## Project Summary

53 Pray Street, Portsmouth, New Hampshire

Auger Building Company

PH 4.2026

Proposed 3-Season Room, Fence and Gate

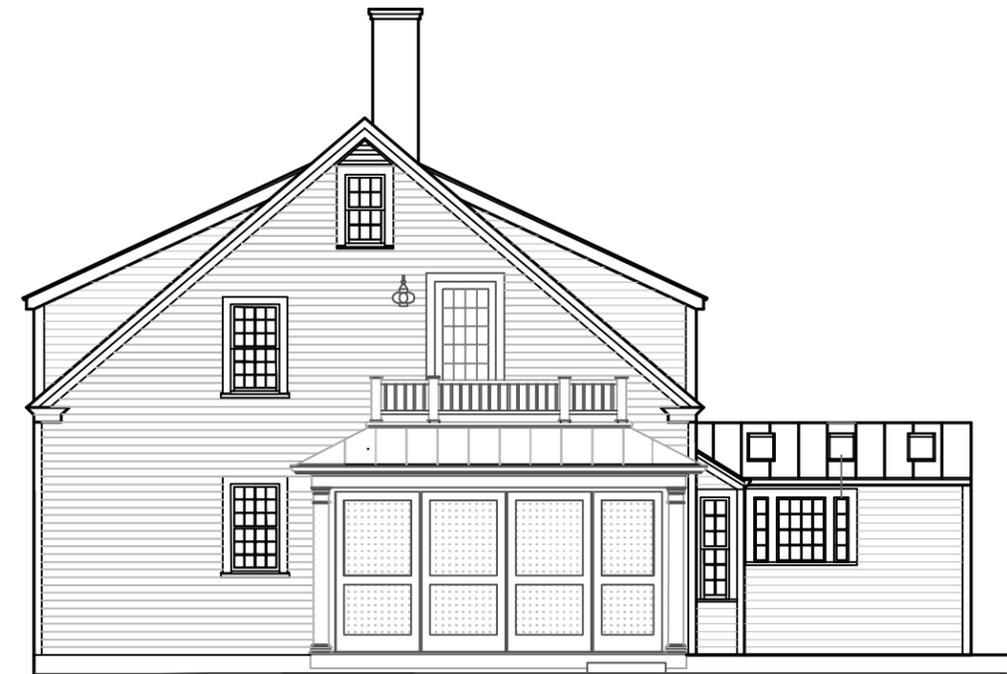
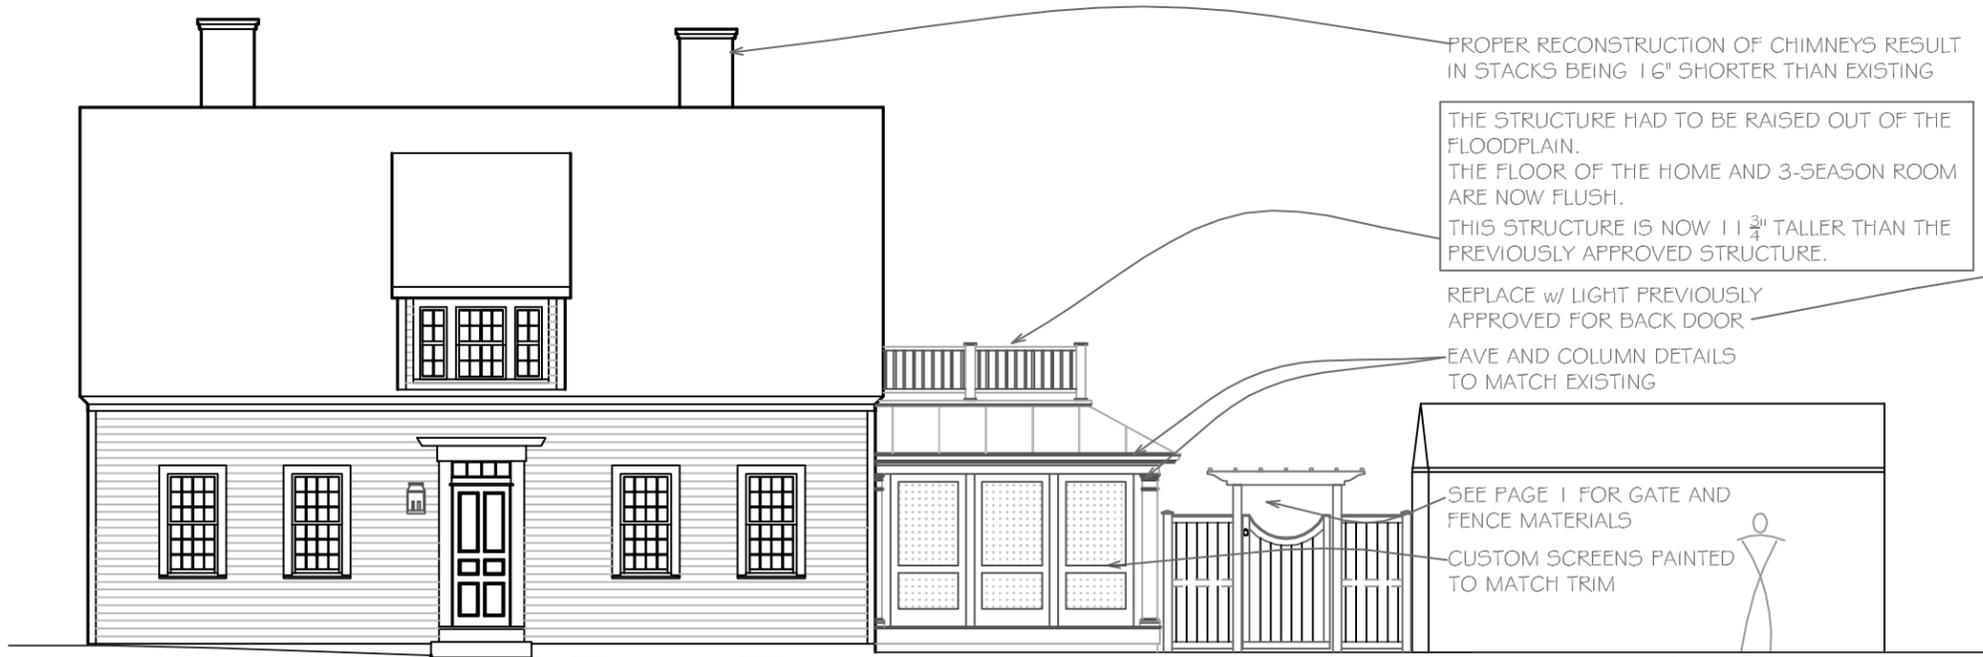
- Rebuild Approved Screened Porch as 3-Season Room. Raise structure to clear floodplain.
- Amendment to previously approved Gate
- Replace and complete fencing along left side and back of yard
- Amendment and Additions to previously approved light fixture(s)
- Amendment to final chimney height based on
- Replace overhead Garage door to be carriage style

Proposed 3-Season Room

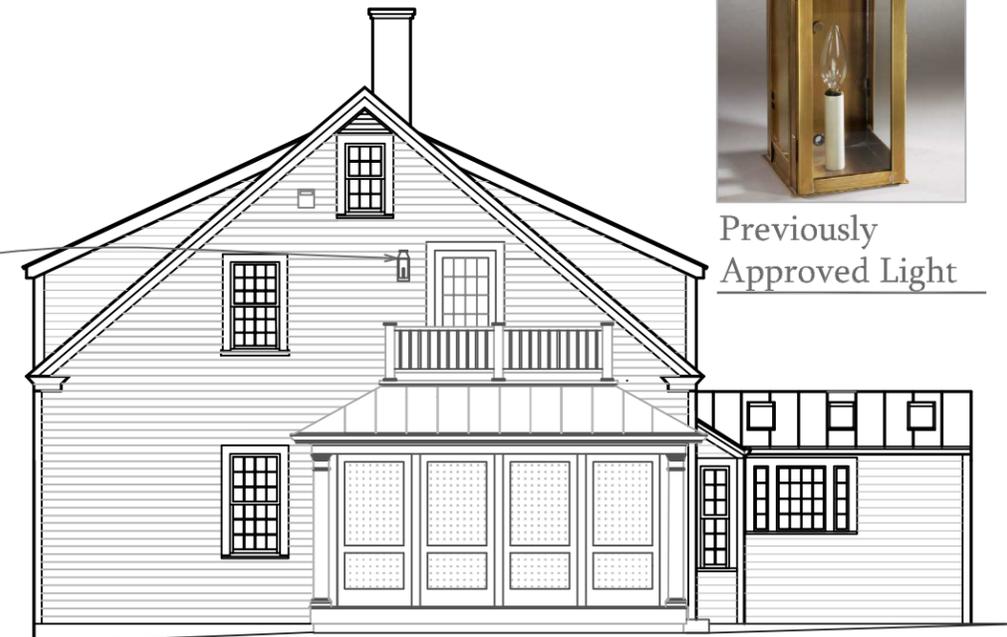
PROPER RECONSTRUCTION OF CHIMNEYS RESULT IN STACKS BEING 1/6" SHORTER THAN EXISTING

THE STRUCTURE HAD TO BE RAISED OUT OF THE FLOODPLAIN. THE FLOOR OF THE HOME AND 3-SEASON ROOM ARE NOW FLUSH. THIS STRUCTURE IS NOW 11 3/4" TALLER THAN THE PREVIOUSLY APPROVED STRUCTURE.

REPLACE w/ LIGHT PREVIOUSLY APPROVED FOR BACK DOOR

EAVE AND COLUMN DETAILS TO MATCH EXISTING

SEE PAGE 1 FOR GATE AND FENCE MATERIALS  
CUSTOM SCREENS PAINTED TO MATCH TRIM

Proposed 3-Season Room, Fence and Gate

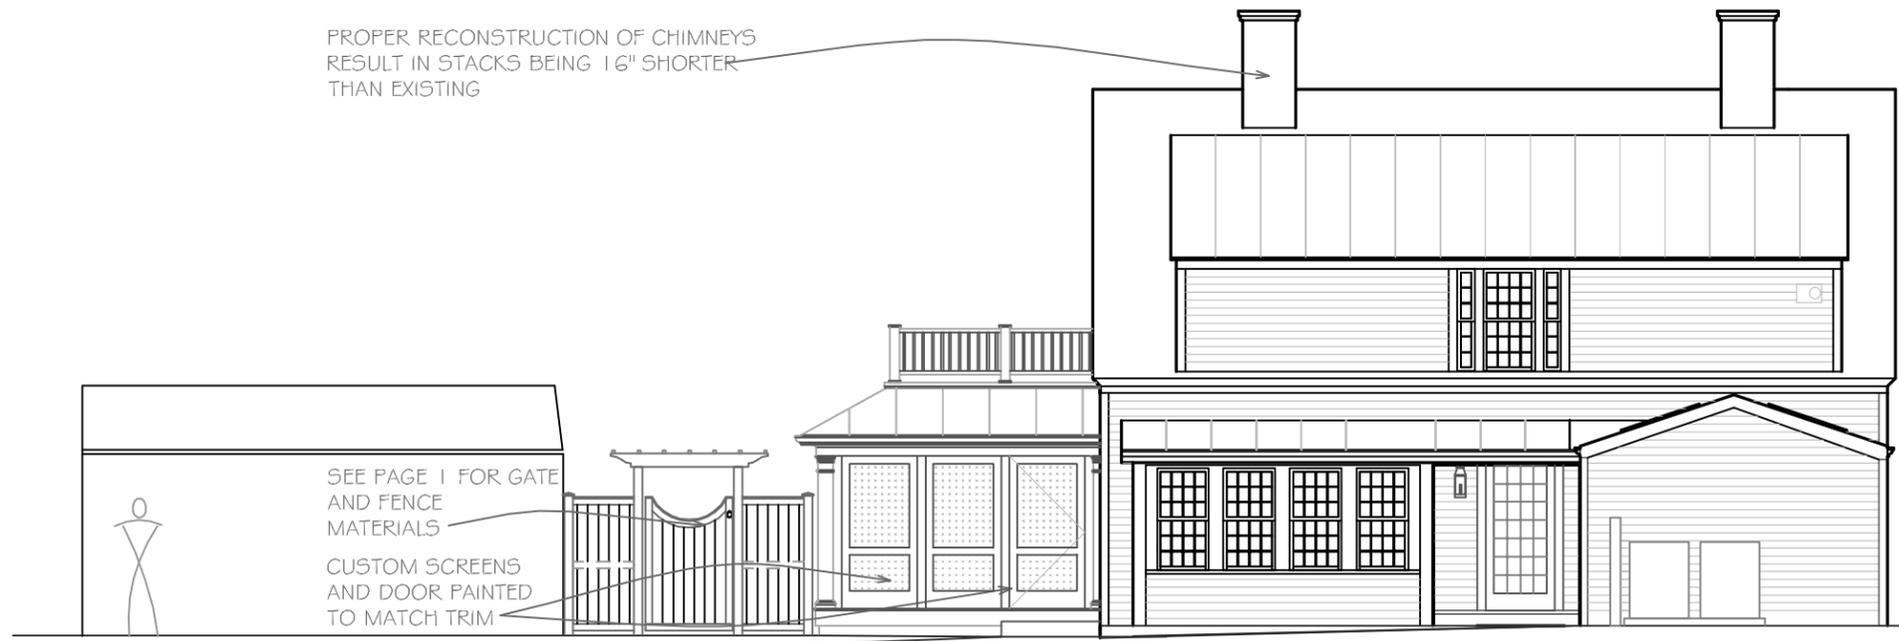
Previously Approved Light

PROPER RECONSTRUCTION OF CHIMNEYS  
 RESULT IN STACKS BEING 16" SHORTER  
 THAN EXISTING

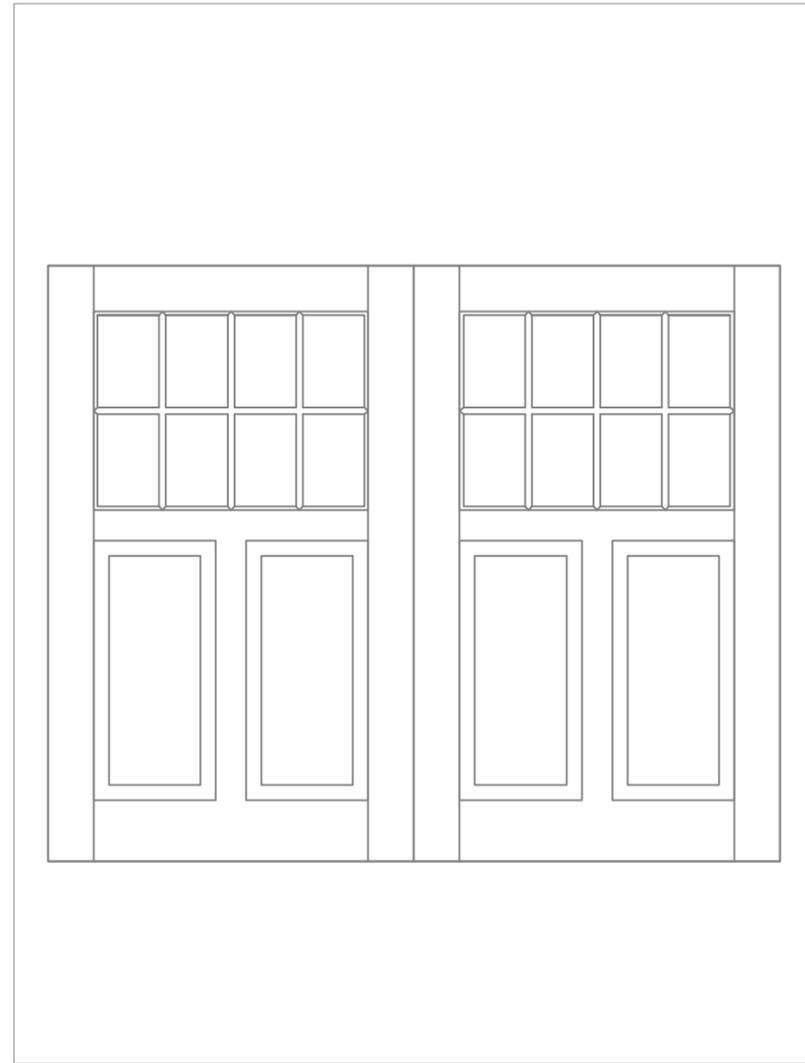
1. Garage Elevation Facing Pray Street  
Garage Door to be replaced. (See 2/Page 4)

2. New Garage Door Elevation  
Custom Wood Door, Painted w/  $\frac{7}{8}$ " SDL Glazing, 'Carriage-Style' (out-swing) operation.

3. Boathouse Elevation Facing Water  
Barn Doors to be removed.  
Add (2) new lights to match previously approved on opposite side, flanking doors. (See Fixture Below)

4. Onion Light  
Previously approved Onion Light
